Request for Additional Information (RAI)
NEDE-33083P, Supplement 1, "TRACG Application for ESBWR Stability Analysis"

Enclosure 1

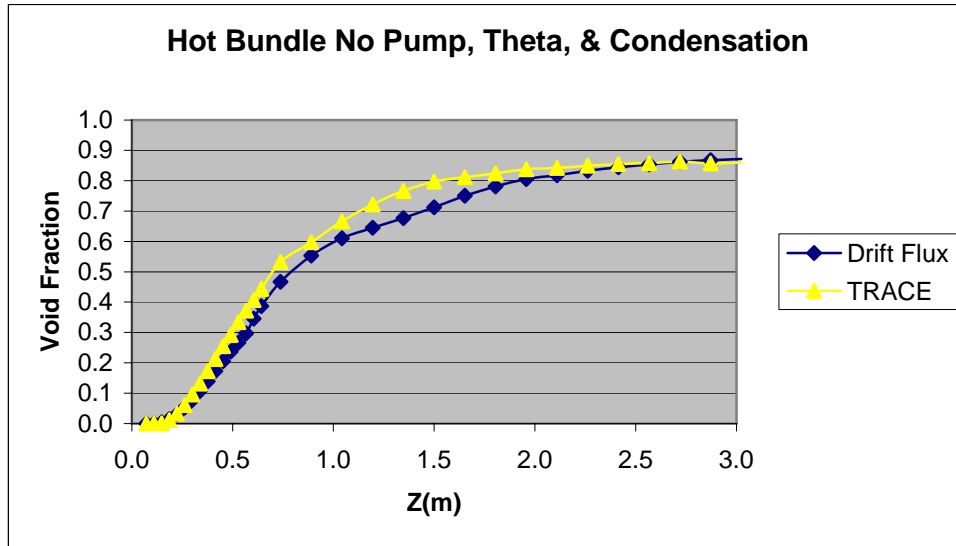
15. As part of the staff's review your interfacial drag models in TRACG, a calculation was performed that predicts void fraction as a function of elevation in the hot bundle. This was performed using TRACE and a standalone drift flux calculation that uses the models in Ref. 1. The staff found that the results were slightly different. This was expected since there are modeling differences between TRACE and the TRACG models in Ref. 1.

TRACG uses the Rouhani-Bowring model² for the energy distribution in subcooled boiling while TRACE uses the Lahey's mechanistic model³. The models are essentially the same, except the TRACE model does not include the pumping factor.

The TRACE model has ε set to zero (i.e. the pumping factor).

Another difference is that TRACE does not include the theta factor for modification⁴ of Co in the subcooled boiling regime, while the TRACG model description indicates that this factor is included.

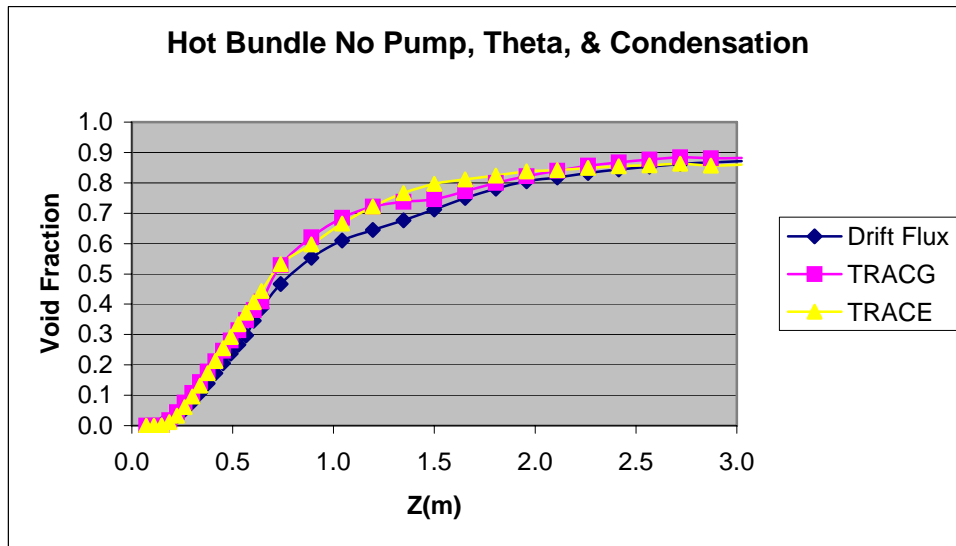
The standalone drift flux model was modified to set the pumping factor to zero, remove the theta factor for modification⁴ of Co in the subcooled boiling regime, and ignore condensation in the subcooled boiling regime. The cases were re-run and the two results agree quite well.

These void fraction profiles were then compared to the TRACG data in the MS Excel file MFN 05-014 Channel Data.

This also agreed quite well, which was not expected. The staff expected that in the subcooled region the TRACG data would agree with the drift flux model in the prior to the modifications since that model is using the same models in Ref. 1.

Please provide the following so that the staff may understand or resolve the differences:

- Confirmation that the pumping factor and theta factor are used in TRACG.
- Axial power profile for the ESBWR hot bundle at steady-state.

- c) Location of the grid spacers and the form loss used for the grid spacers and the flow area for the grid spacers.
 - d) Provide a density wave propagation time based on the TRACG results.
